SUMMARY OF CHANGES:

PROJECT
URBN SURF SYDNEY
HILL ROAD, SYDNEY OLYMPIC PARK NSW

STATUS \$4.55 DEVELOPMENT APPLICATION	DRAWING LEGEND AND MATERIALS SCHEDULE
DRAWING SCALE	NORTH POINT
PROJECT No S19-023	SHEET SIZE A1
DRAWING No L001	ISSUE D

DRAWING
ILLUSTRATIVE MASTERPLAN

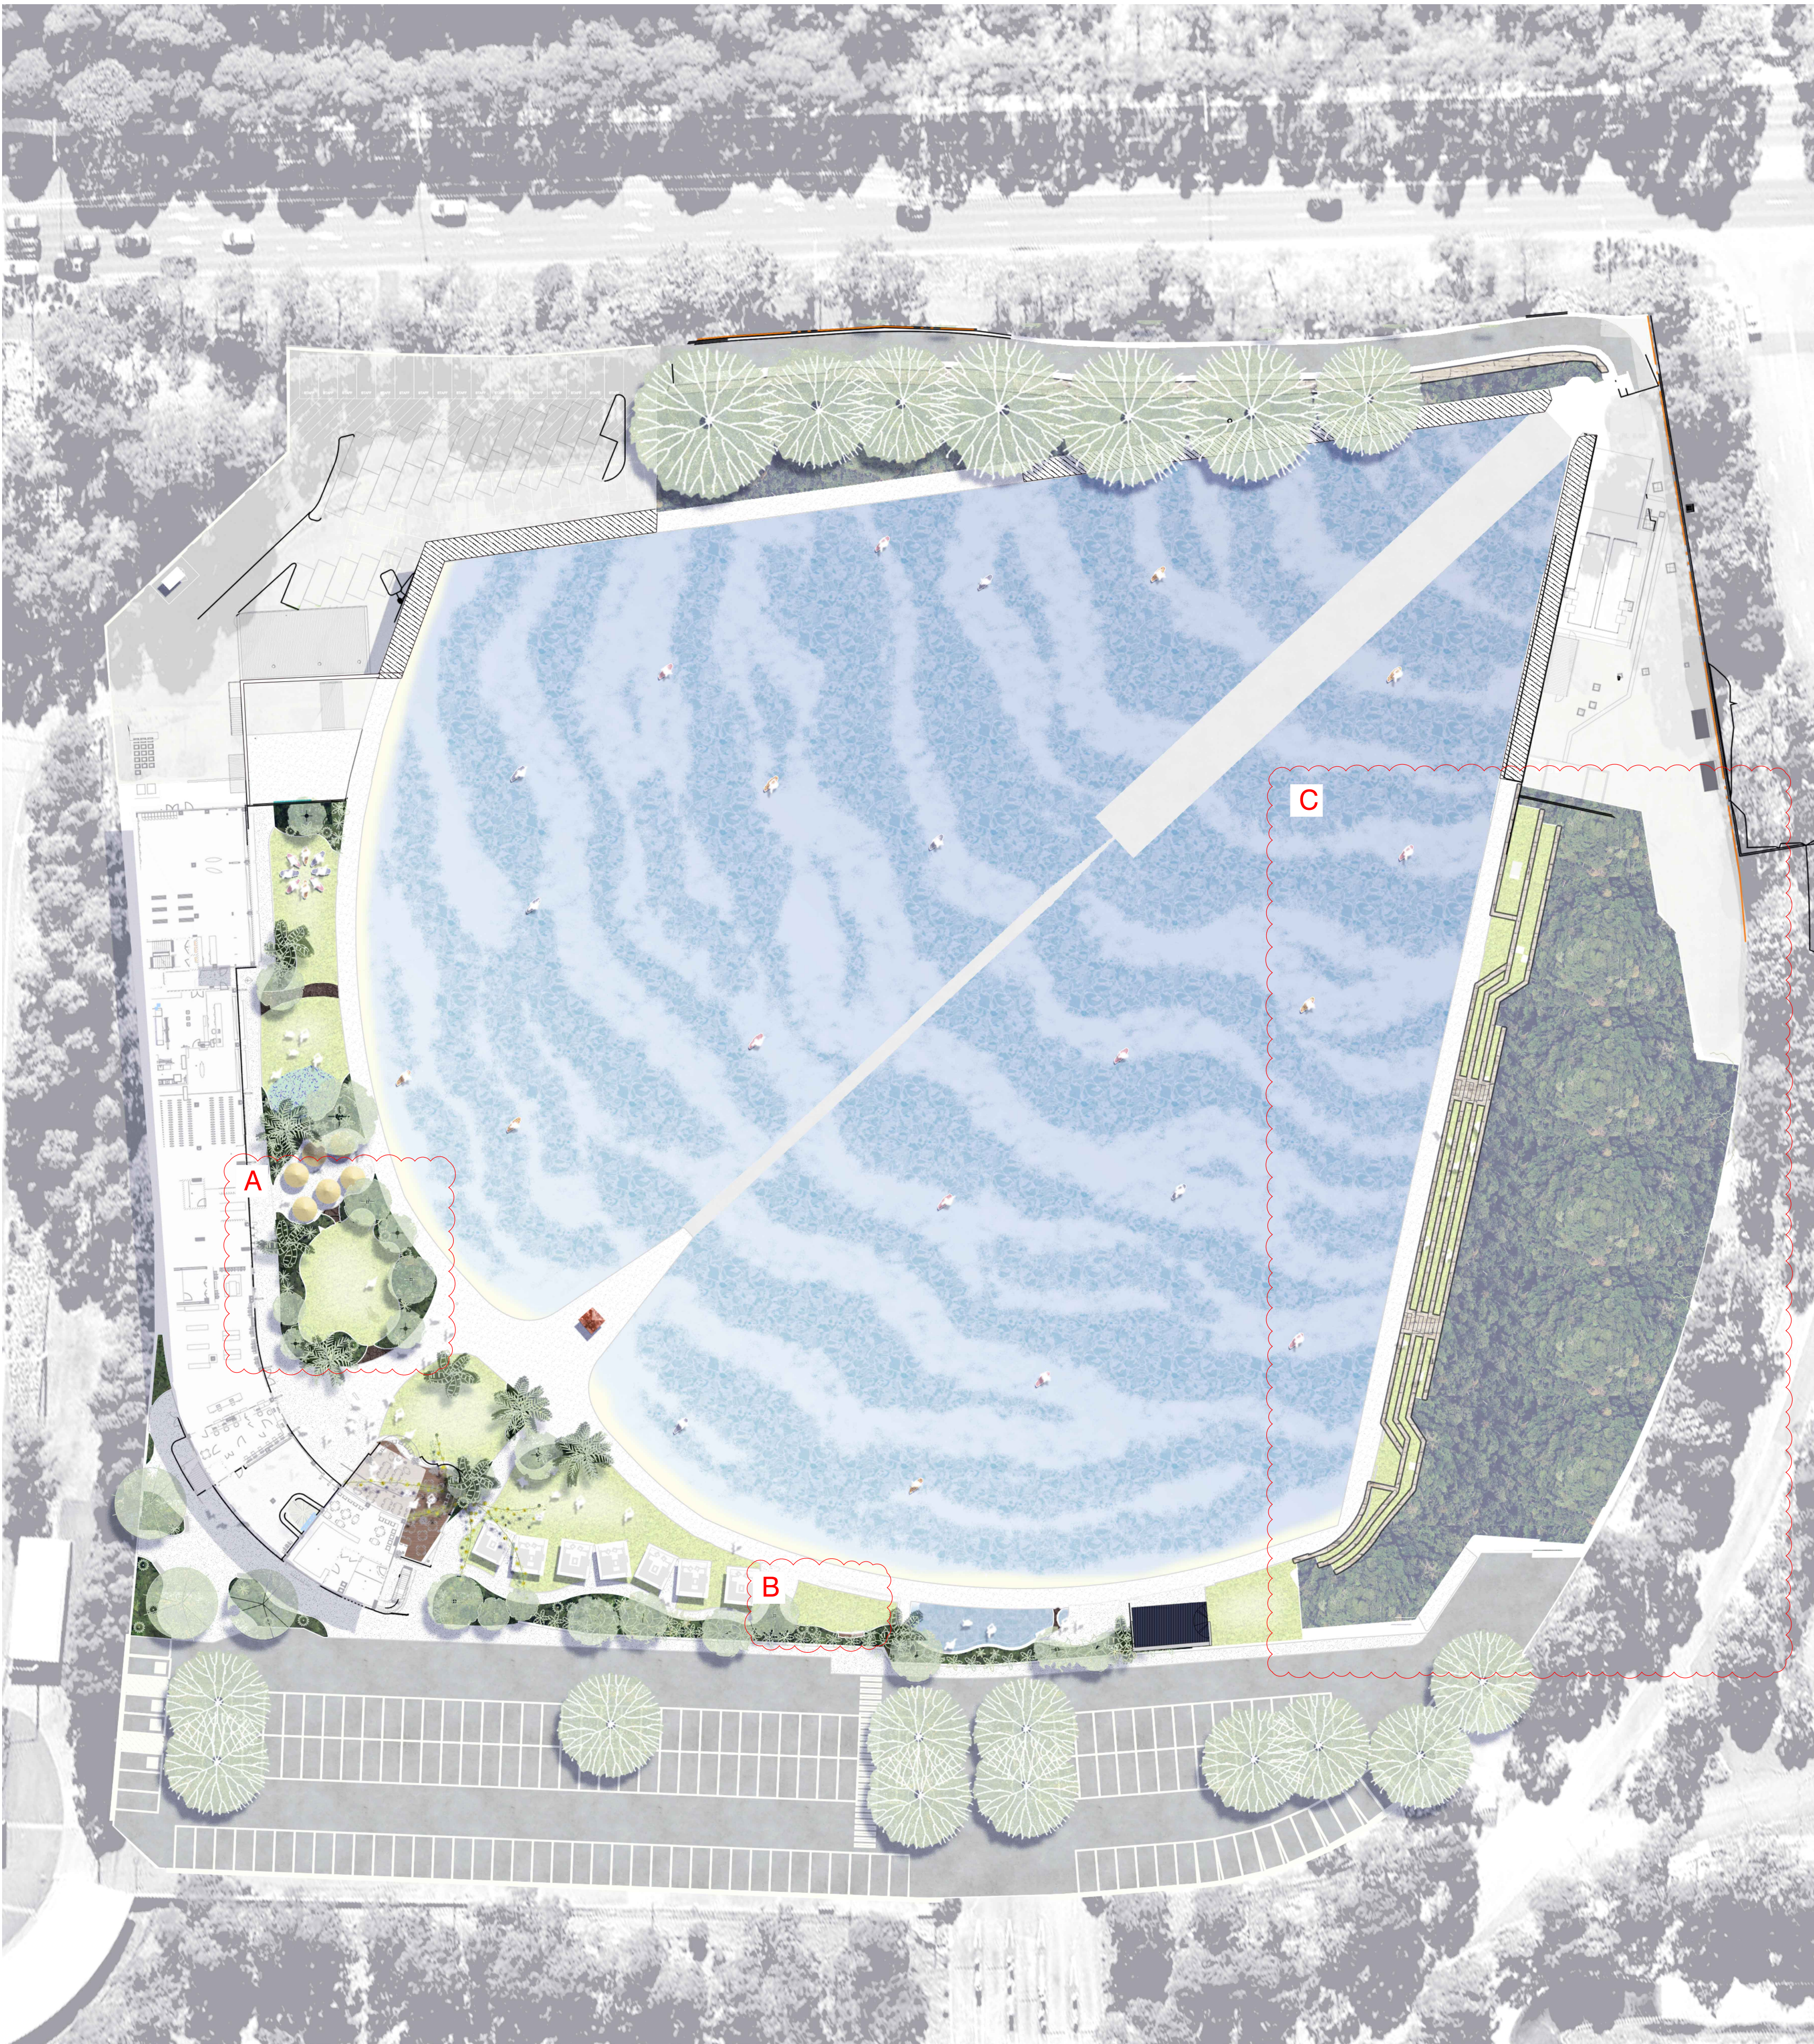
- A. NATURE PLAYGROUND REPLACED WITH FLAT LAWN SPACE
- B. KIDS POOL REPLACED WITH FLAT LAWN SPACE
- C. EVENTS HILL DESIGN UPDATED

DRAWING
SITE PLAN

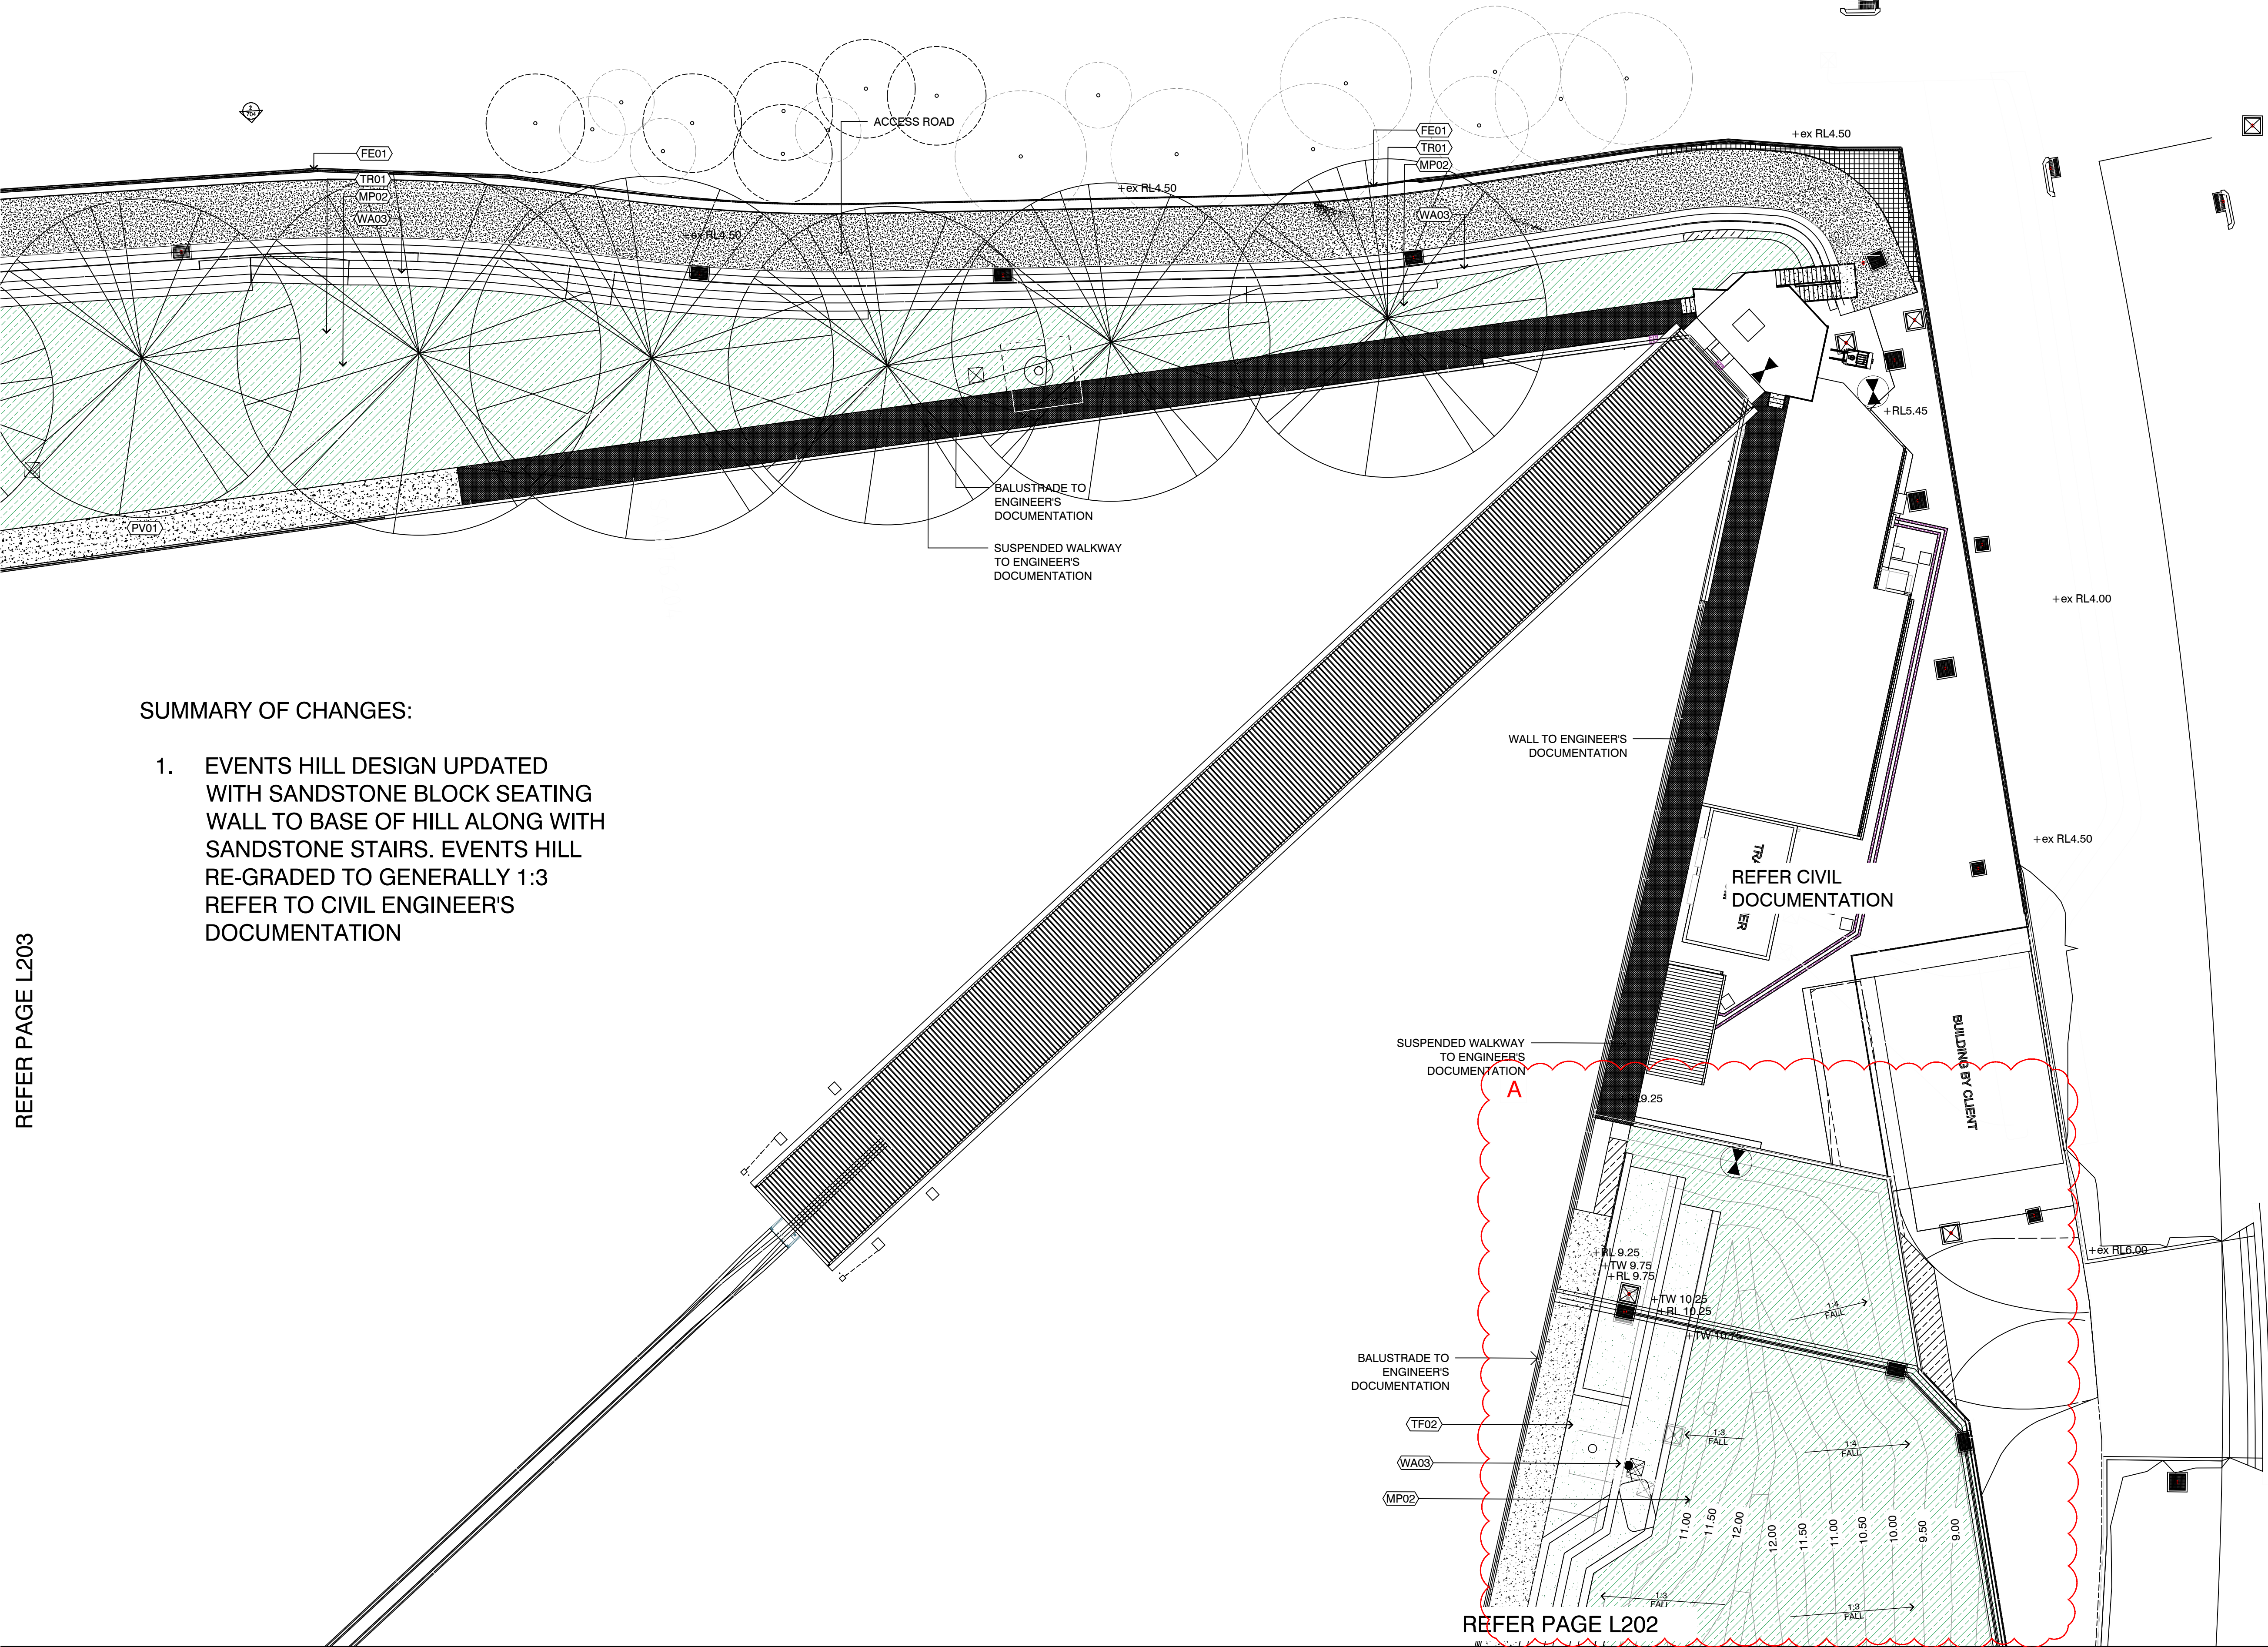
- A. NATURE PLAYGROUND REPLACED WITH FLAT LAWN SPACE
- B. KIDS POOL REPLACED WITH FLAT LAWN SPACE
- C. DESIGN LAYOUT UPDATED WITH MAINTENANCE SHED RELOCATED TO THIS SPACE
- D. EVENTS HILL DESIGN UPDATED

- A. NATURE PLAYGROUND REPLACED WITH FLAT LAWN SPACE. TIMBER LOG EDGE REPLACED WITH STEEL EDGE. PLAYGROUND ELEMENTS NO LONGER IN USE
- B. KIDS POOL REPLACED WITH FLAT LAWN SPACE
- C. FURNITURE REMOVED IN THIS SPACE. MAINTENANCE SHED RELOCATED
- D. CUSTOM AGGREGATE CONCRETE PAVING REPLACED WITH PV01 INSITU CONCRETE PAVING

DRAWING
SURFACE FINISHES
AND MATERIALS

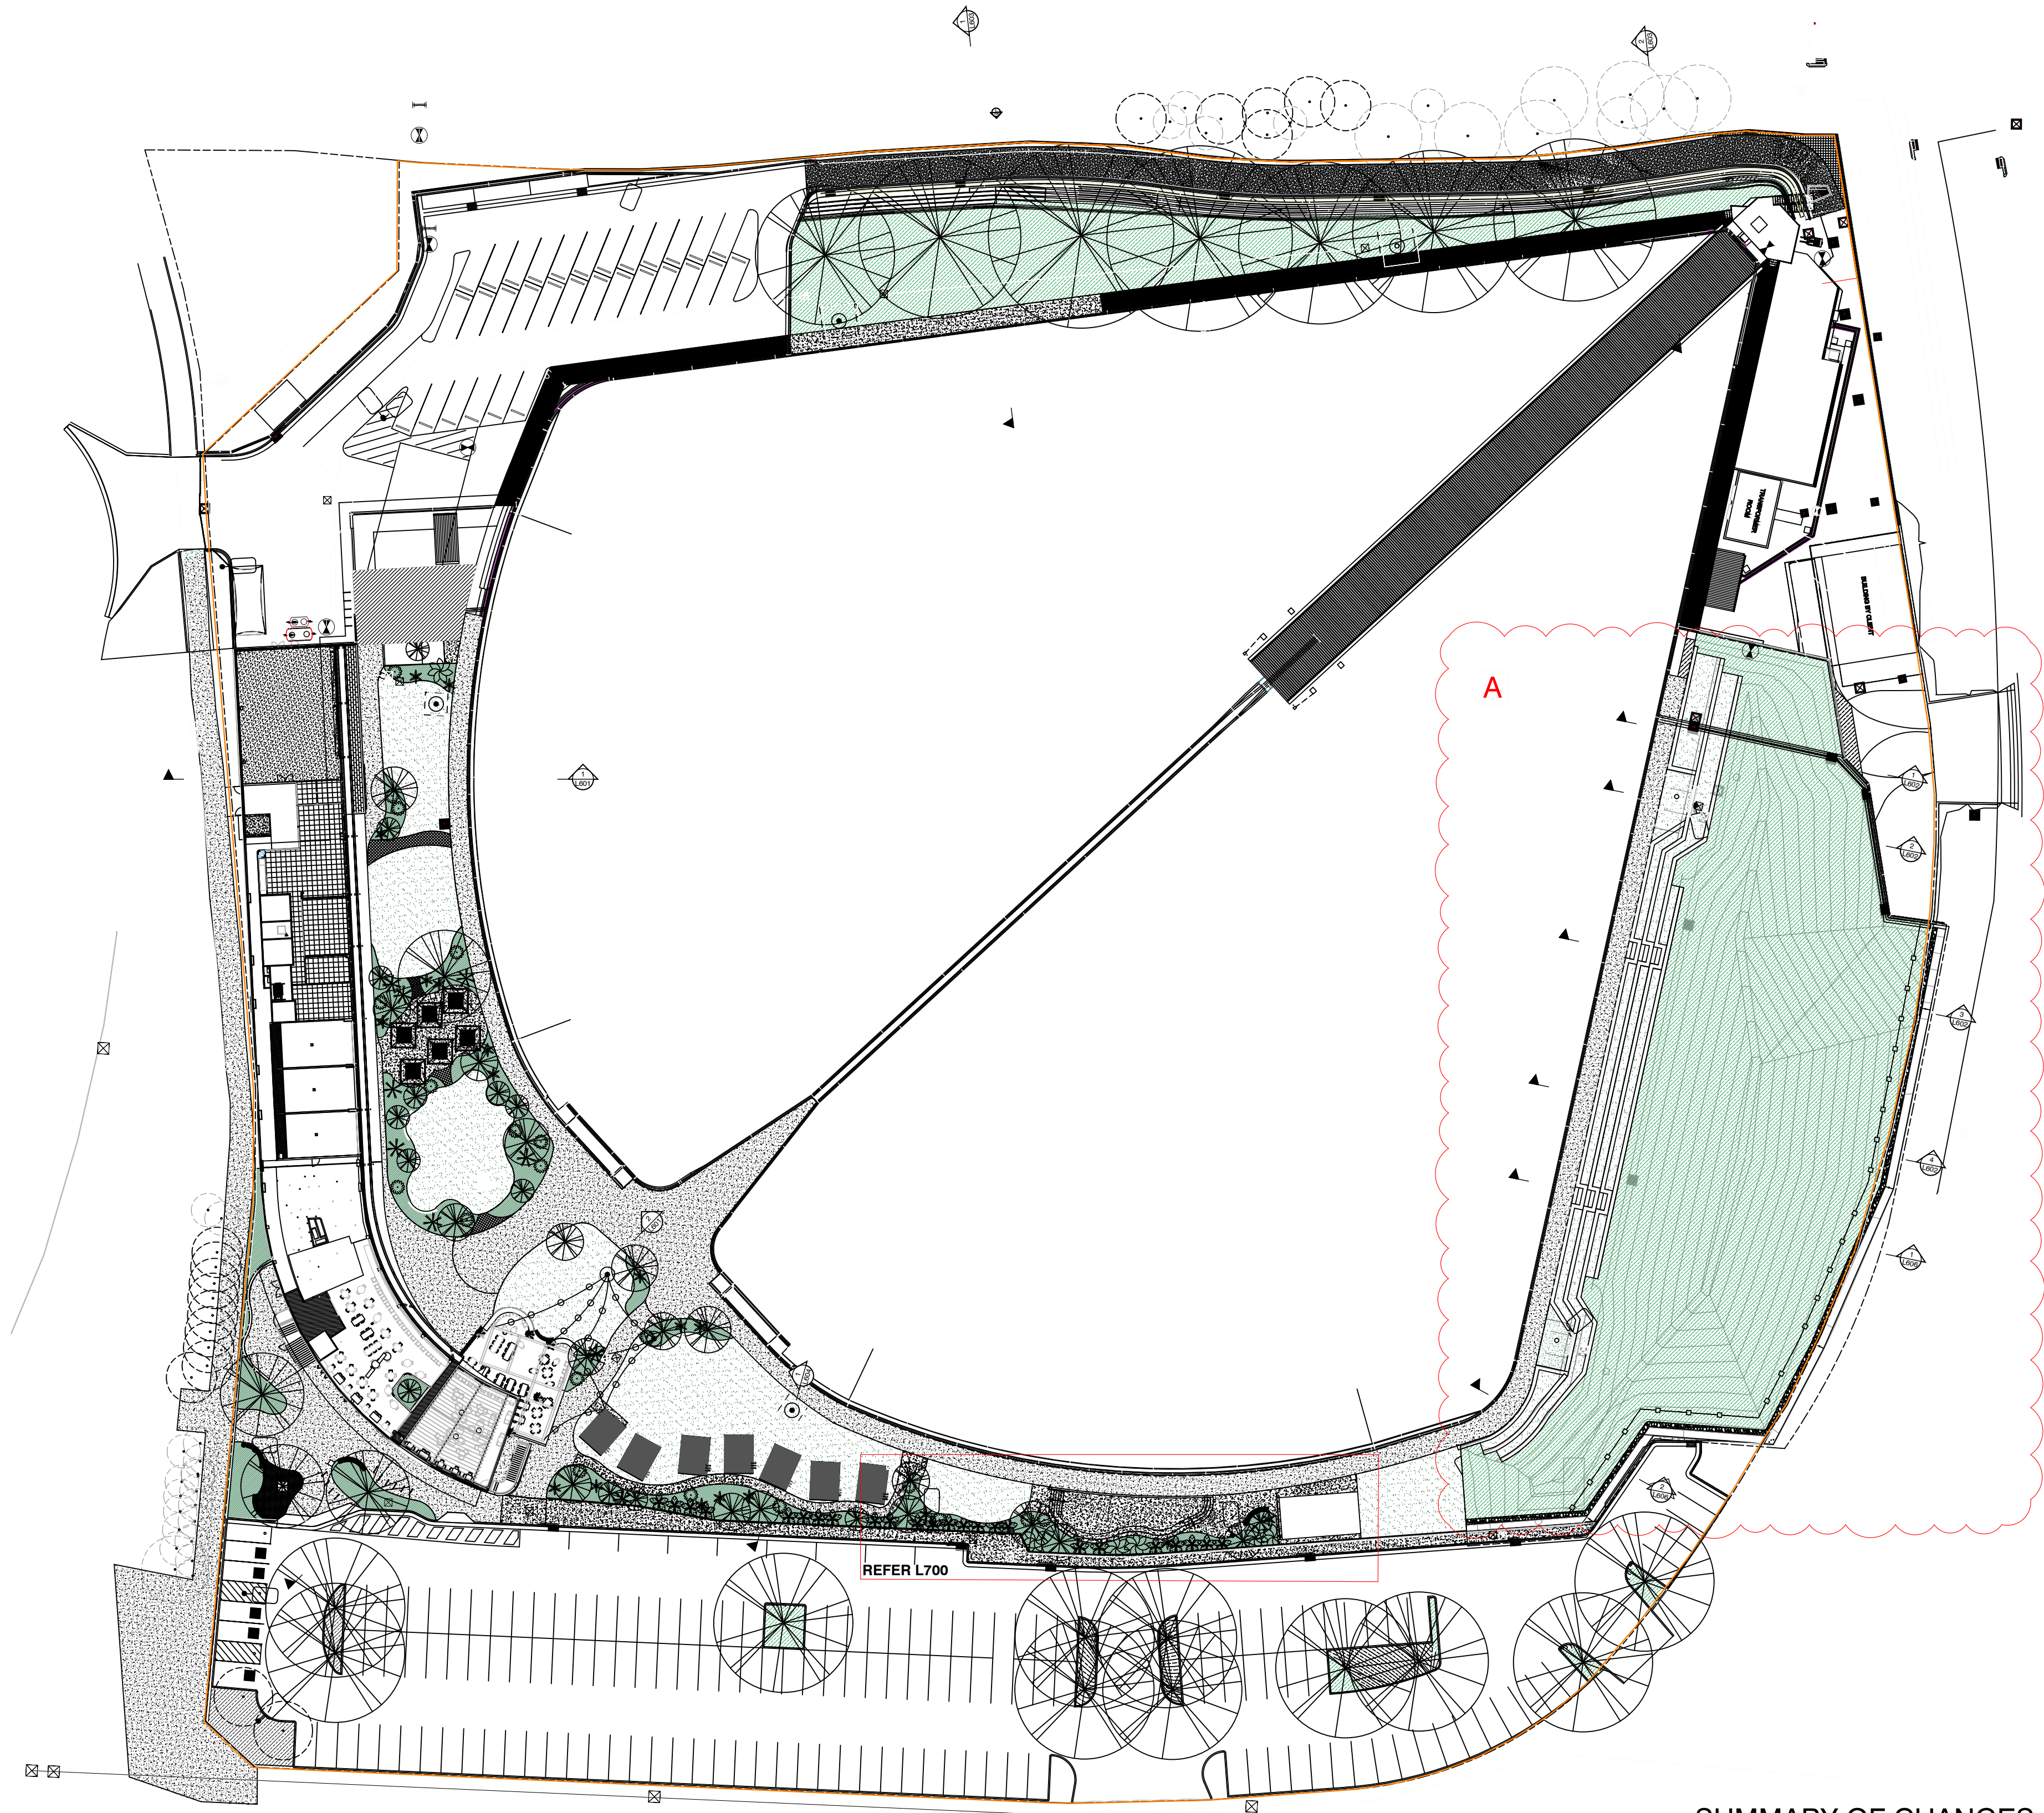
1. EVENTS HILL DESIGN UPDATED WITH SANDSTONE BLOCK SEATING WALL TO BASE OF HILL ALONG WITH SANDSTONE STAIRS. EVENTS HILL RE-GRADED TO GENERALLY 1:3 REFER TO CIVIL ENGINEER'S DOCUMENTATION
